PRODUCT ADVISORY

PA-1010A

Models Affected: All Aerial Devices and Digger Derricks

SUBJECT: *Vehicle Level/Slope Indicators*

Indicator which allows 5-degree slope – Part Number 486277

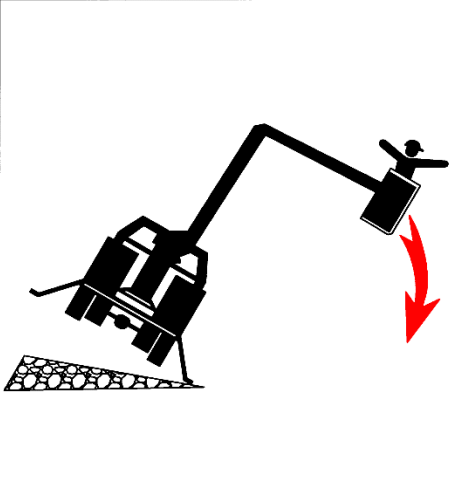
When remounting Aerials or Digger Derricks which are not equipped with Slope Indicators, they must be added to comply with the current standards. Below are sample Slope Indicator decals for units allowed to be set up on a 5-degree slope. The specific Slope Indicator and instruction label required on a machine will depend on the unit.

The Decal and Slope Indicator must be installed visible to the person setting the vehicle up. One indicator must show side to side and one indicator must show front to back slope of the vehicle. Install so the indicator is at zero when the vehicle bed is level.
